Reactor Protective System Trip Setting Limits

ATTACHMENT 2
TECHNICAL JUSTIFICATION

TECHNICAL JUSTIFICATION

Figure 1

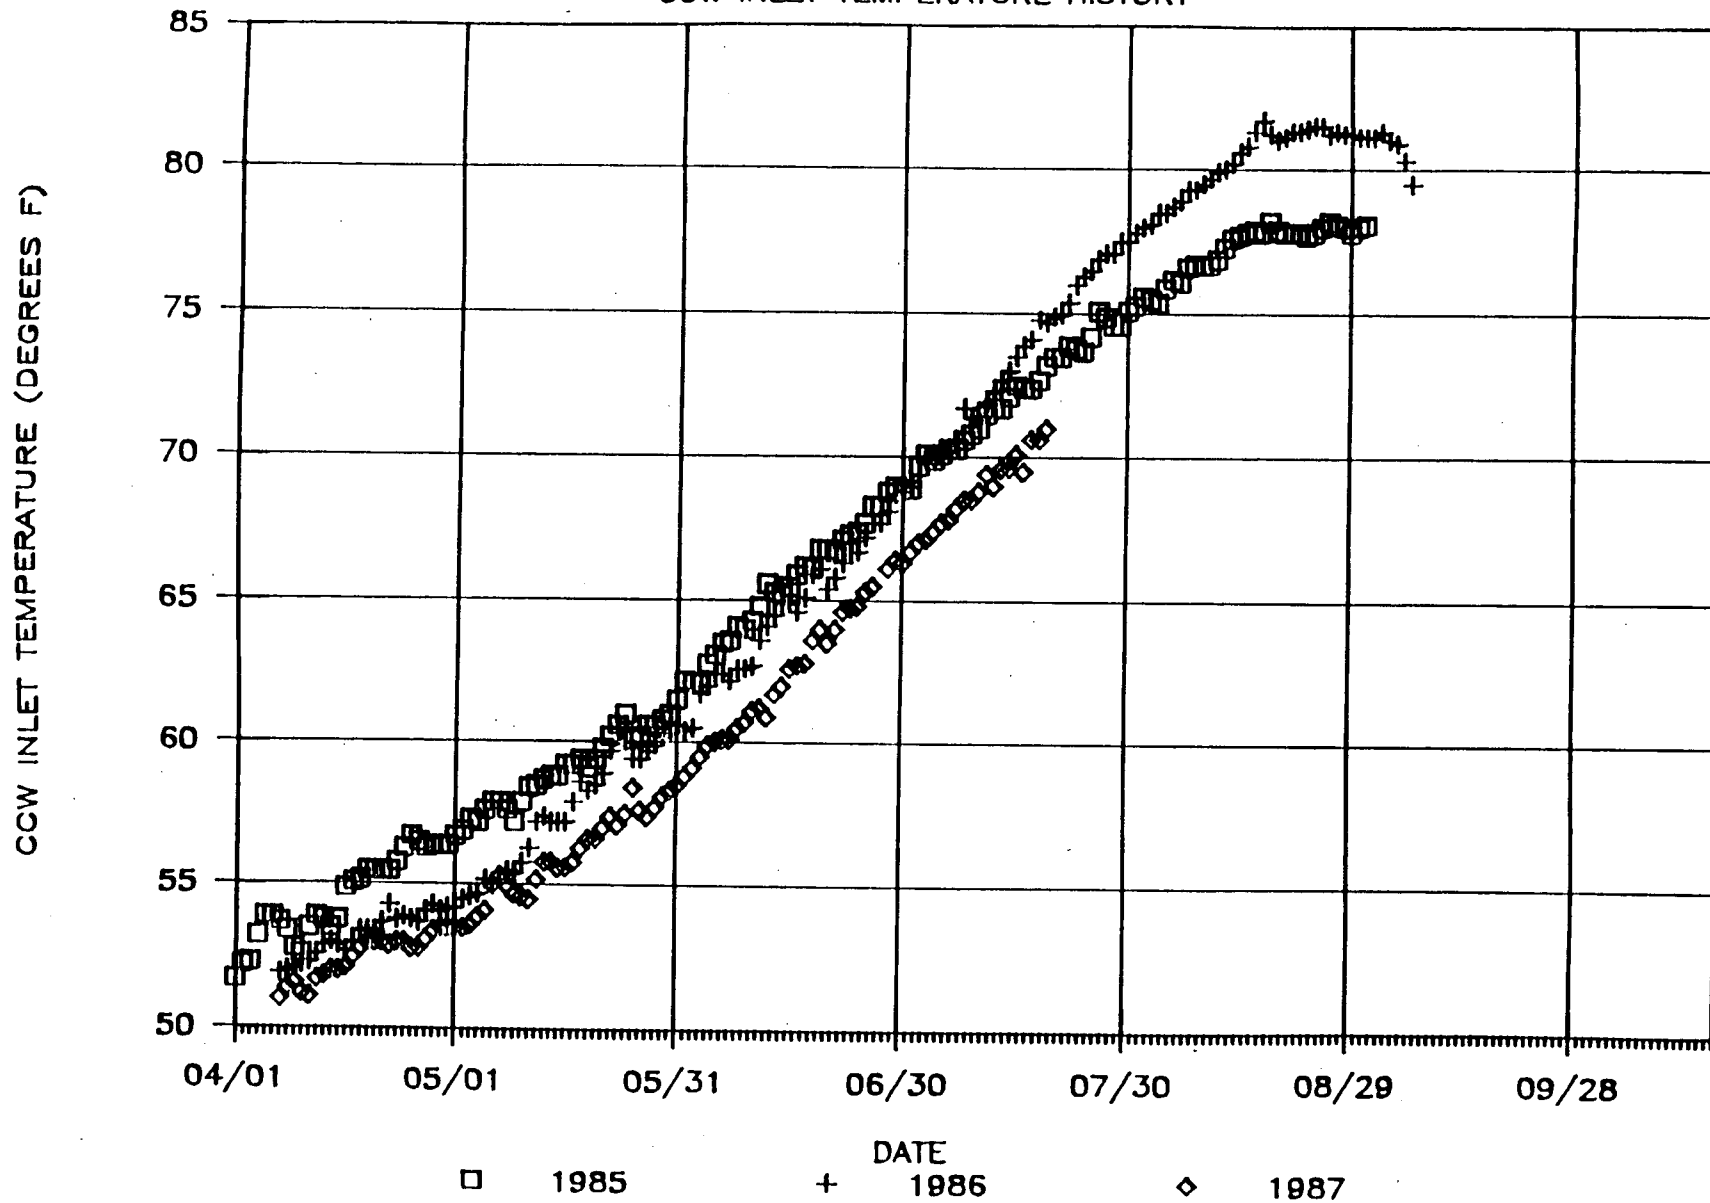
The Oconee FSAR states in various data tables that a lake temperature of 75 degrees F was used for certain equipment design and analysis. Recent studies by Duke Power have indicated, and historical data have shown, that 75 degrees F is not a conservative value. The recent design studies suggest a new hypothetical maximum intake temperature of 85 degrees F. By comparison, the maximum intake temperature recorded in 1986 was 81.8 degrees F on August 11, and in 1985, 79.6 degrees F was recorded on September 8. The intake temperature has exceeded 75 degrees F, for varying lengths of time, for 9 of the past 11 years, but has exceeded 80 degrees F only once in operating history. Table 1 summarizes these instances for the years 1976-1986. The 1986 meteorological and lake conditions resemble those assumed in design studies with respect to maximum and average air temperature and sunlight available. In addition, precipitation and lake level were slightly lower than what was assumed in the design studies. A compensating factor which contributed to intake temperatures not exceeding 81.8 degrees F was the outage of Unit 1 from February 13, 1986 to May 5, 1986 and a Unit 2 outage in August, 1986. Figure 1 shows the temperature vs. time data for 1985 and 1986 plotted graphically, and year-to-date temperature data for 1987. Evidently, 75 degrees F can be expected to be exceeded by July 28, 1987, however based on temperature trend data, it is not anticipated that the lake temperature will exceed 80 degrees F this year.
